Service Bulletin

Bulletin No.: 19-NA-025

Subject: Front Turn Signal Lamp Flashing Fast, or Inoperative

5233432

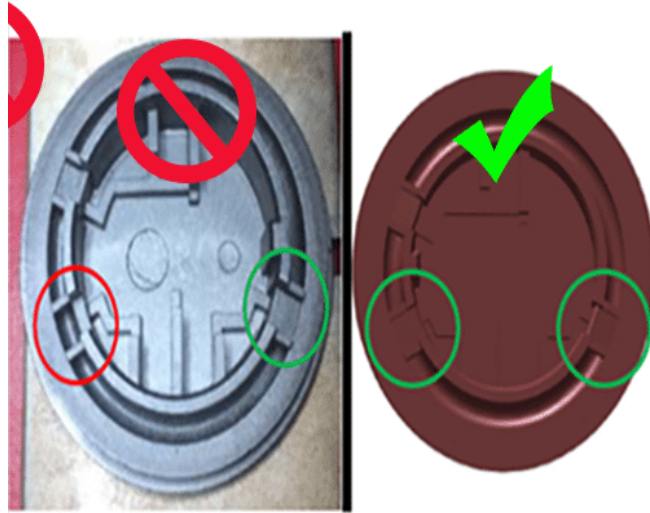
Involved Region or Country	North America, Middle East, Israel
Additional Options (RPOs)	EXC - LED LAMP FRT TURN SIGNAL (UGC)
Condition	<div></div> <p>5233431</p> <p>Some customers may comment on a front turn signal flashing fast or inoperative.</p>
Cause	The cause of the condition may be that the original lamp socket body was molded with a void under the terminal pins (1). This space would sometimes allow the terminal to move, resulting in an intermittent or complete loss of contact to the ring inside the lamp.

Note: A design change was made to the socket mold to fill in the void area. The graphic above shows the void filled in to eliminate terminal movement and correct the condition.
